ADDENDUM # 1

PROJECT: P S J A I. S. D.
Carnahan, Franklin & Buell
HVAC Additions to Gyms
Bid # 18-19-052

ARCHITECT: EGV Architects, Inc.
220 S. Bridge
Hidalgo, TX 78557
(956) 843-2987

NOTES:
1) HIGHLEG ON PHASE-C. FIELD VERIFY EXISTING HIGHLEG ASSIGNED PHASE.
2) PROVIDE WITH 300AMP MAIN BREAKER.
3)

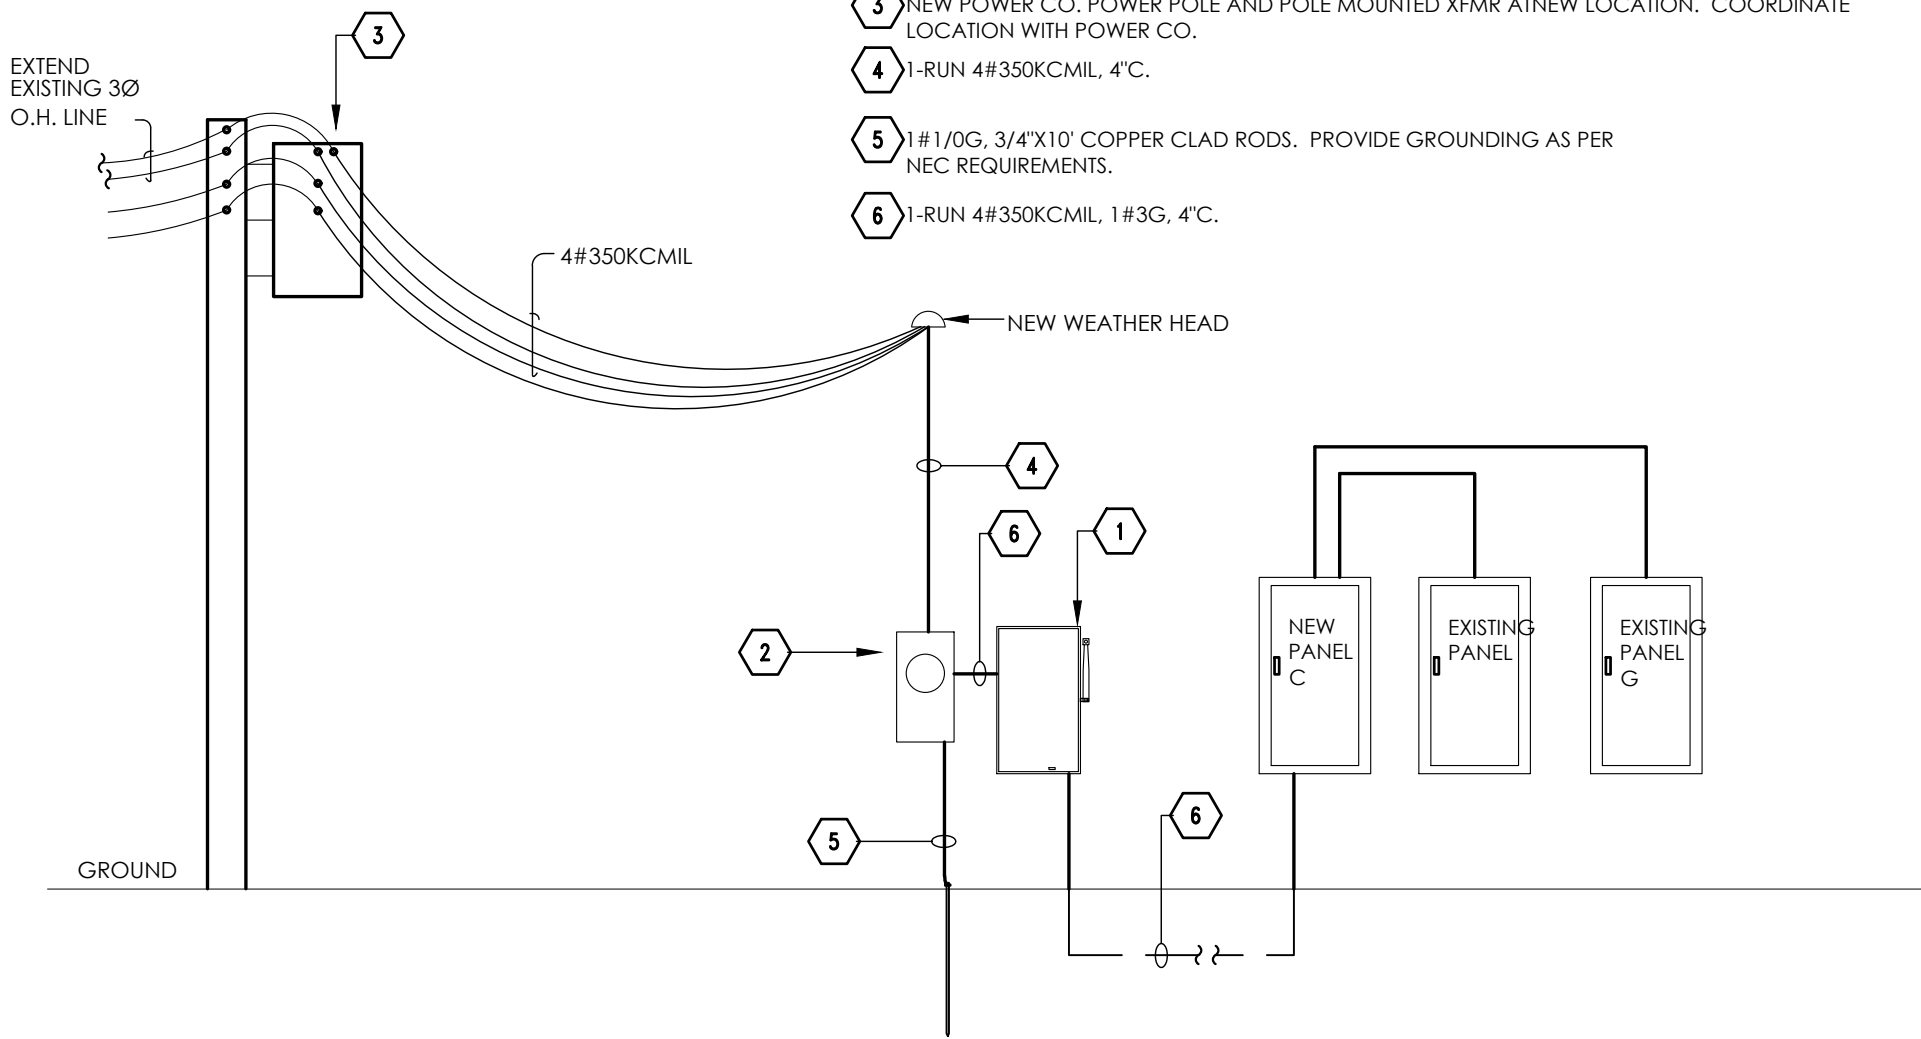
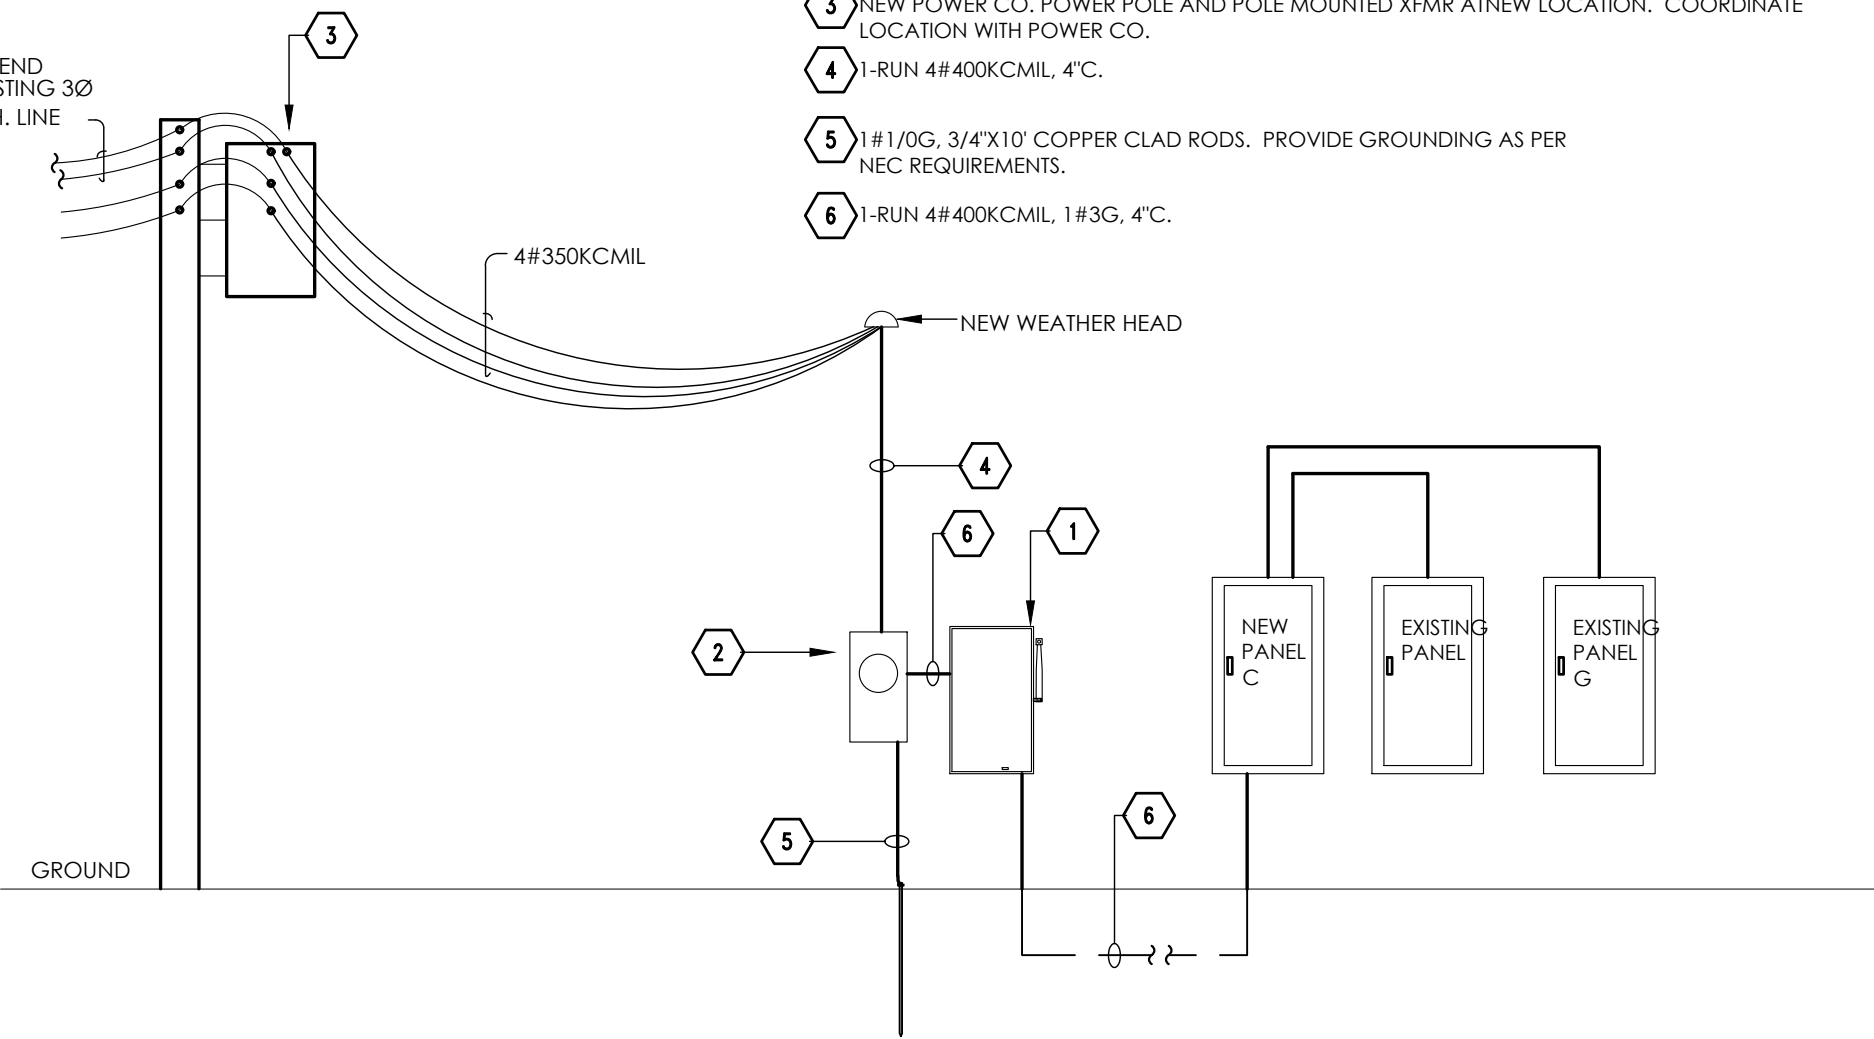
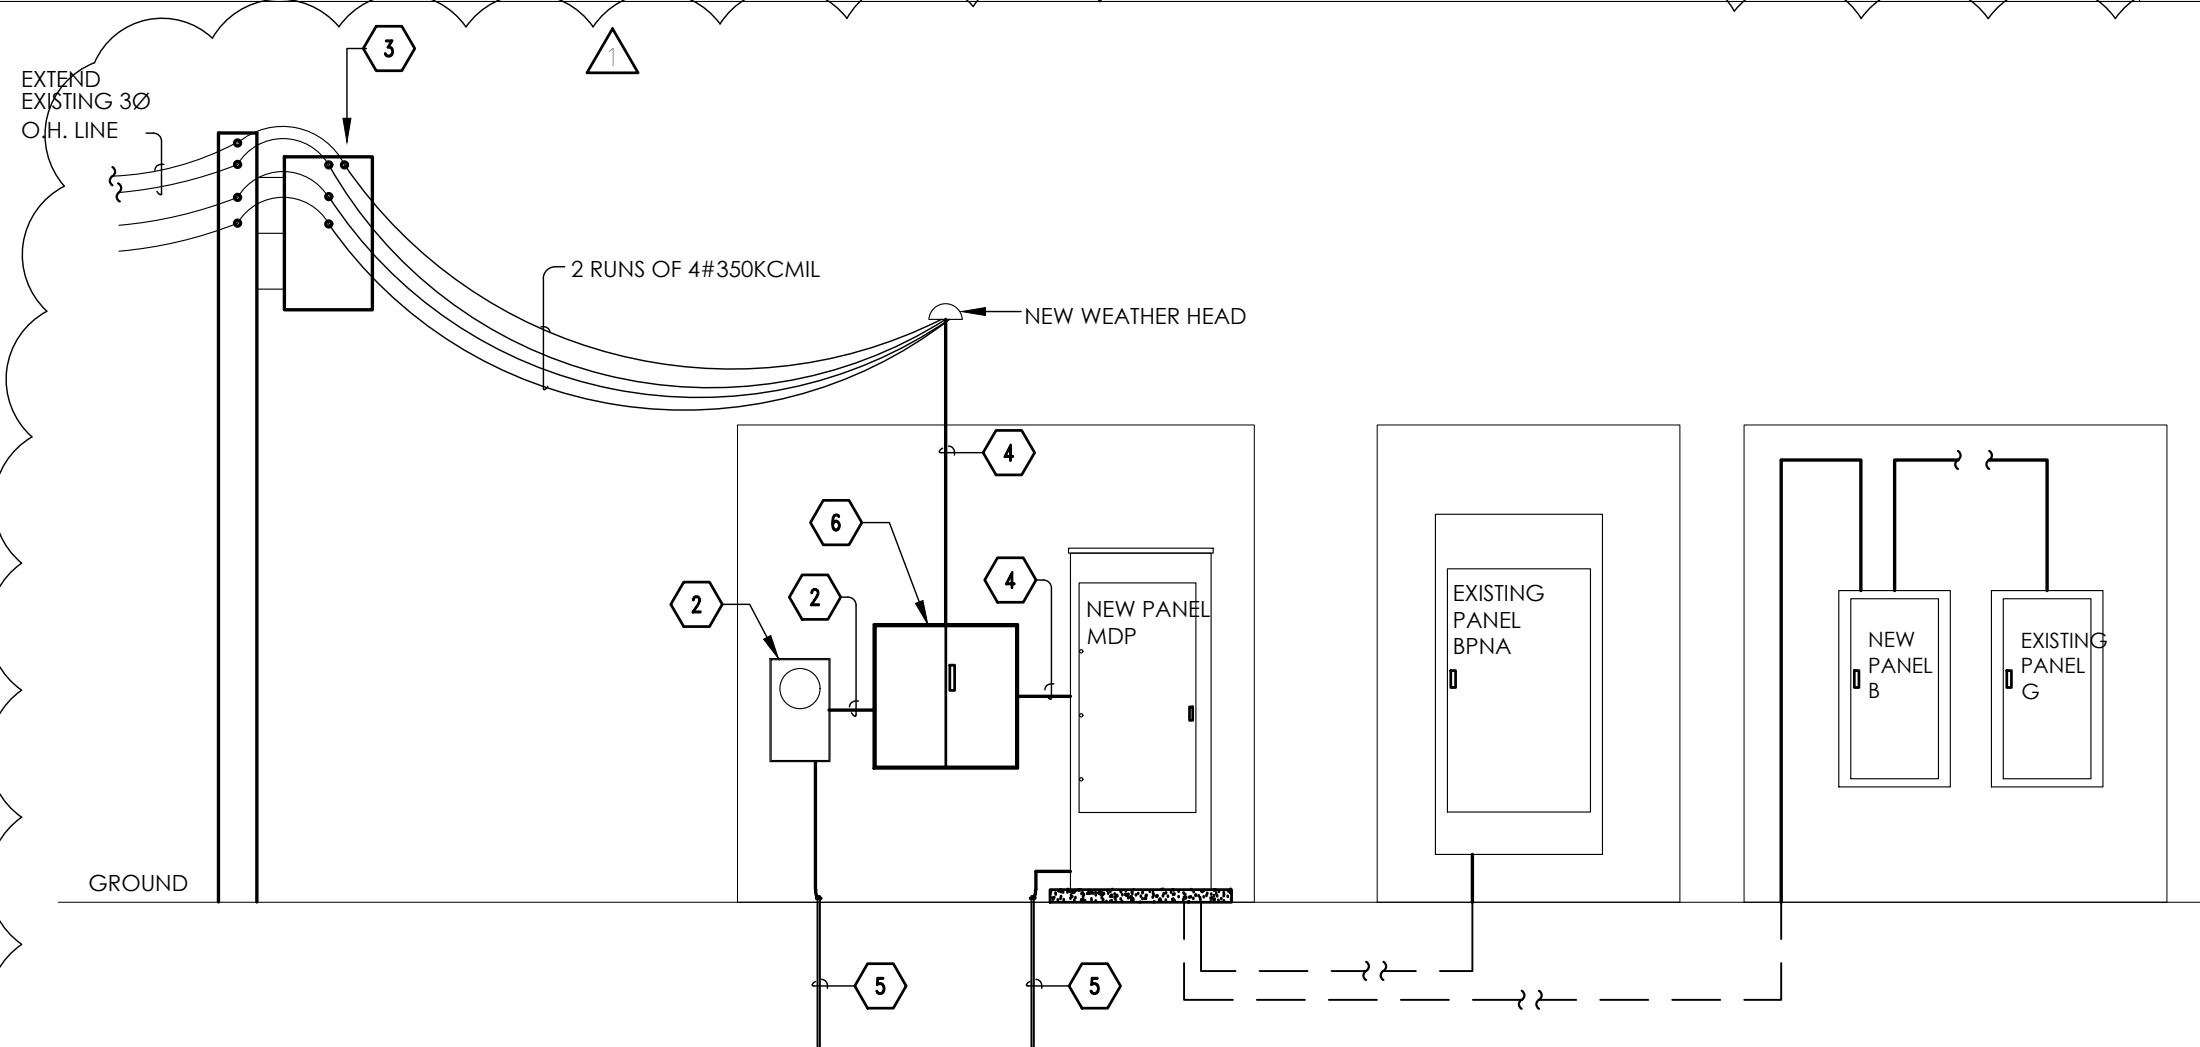
1. Sheet E0.0 – Revised Light fixture schedule.
2. Sheet EB1.0 – Revised plans refer to Addendum #1.
3. Sheet EB1.1 – Revised plans refer to Addendum #1.
4. Sheet EH1.1 – Revised plans refer to Addendum #1.
5. Sheet EI1.1 – Revised plans refer to Addendum #1.
6. Sheet E1.1 – Revised electrical riser and schedules. Refer to Addendum #1.

FH1.0

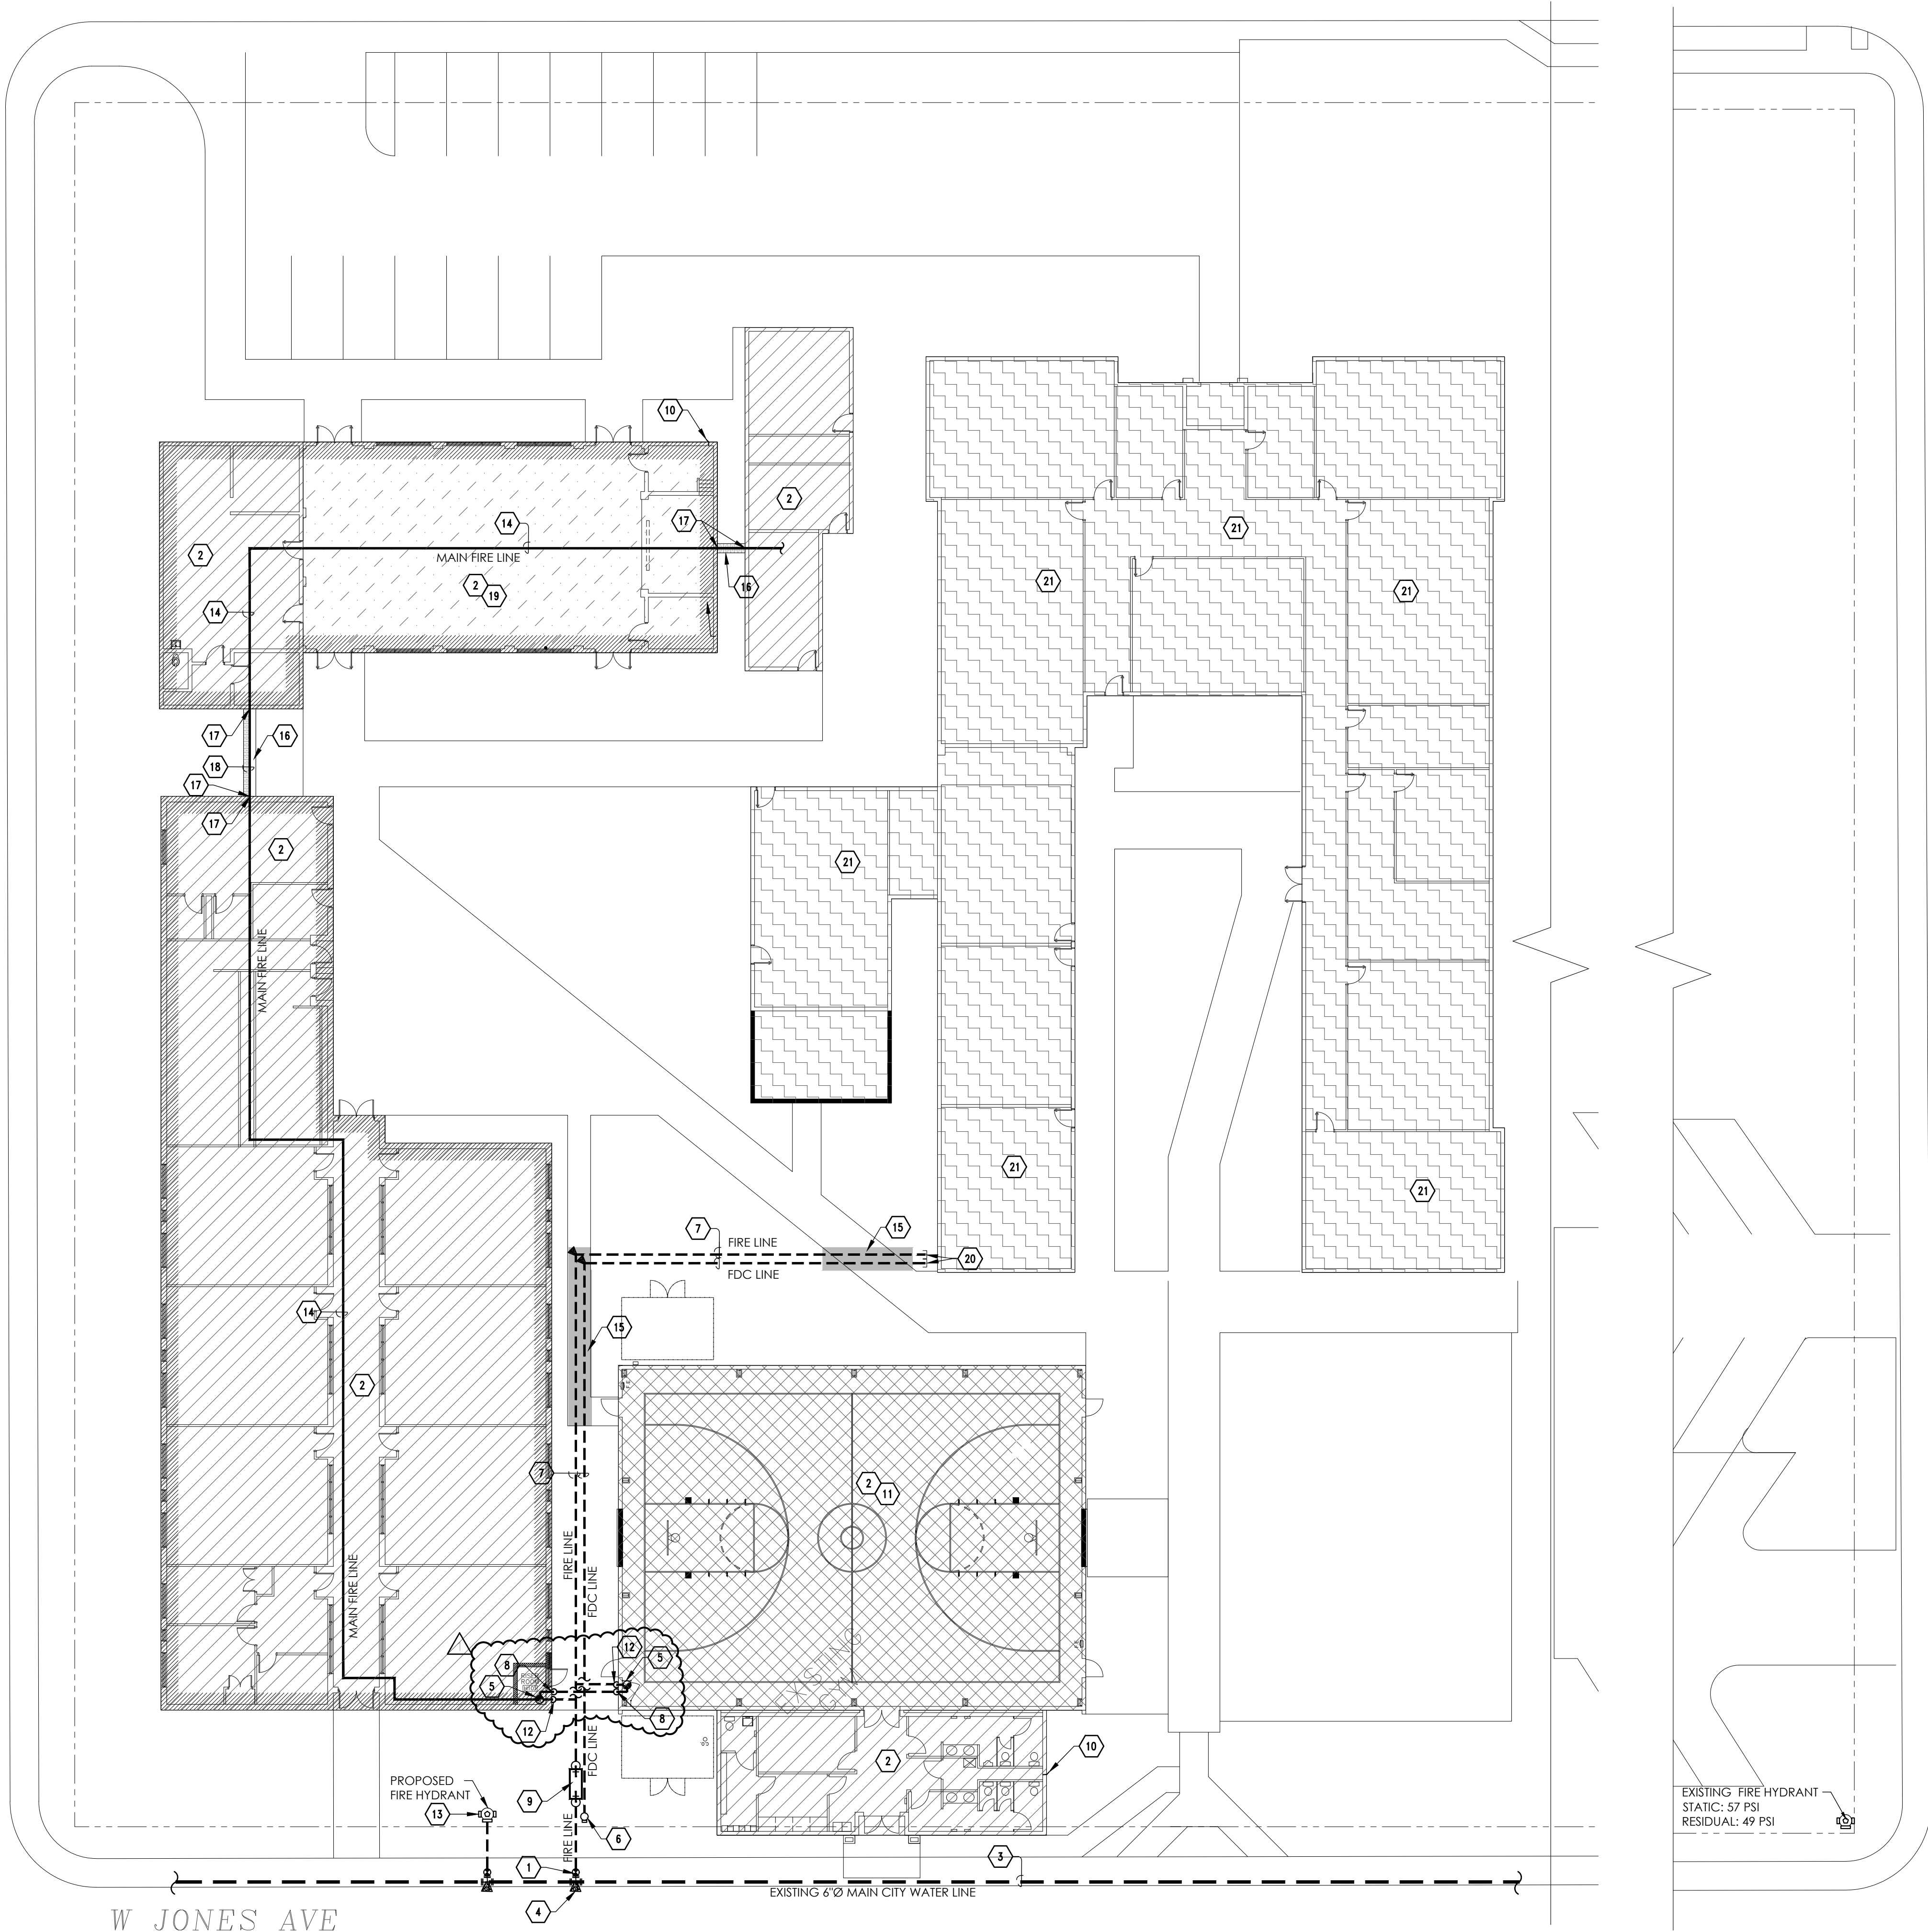
1. Sheet FH1.0 – Revised Keynote #5 refer to attachment FH1.0.
2. Sheet FH1.0 – Revised Fire Line And F.D.C. Line refer to attachment FH1.0.

- 5 FIRE SPRINKLER SYSTEM RISER SHALL BE PLACED IN THIS PROPOSED RISER ROOM. REFER TO DETAIL #4.
- 6 PROVIDE FREE STANDING F.D.C. COORDINATE EXACT LOCATION WITH A.H.J. PROVIDE SIGN WITH BUILDING IT SERVE. REFER TO DETAIL #5.
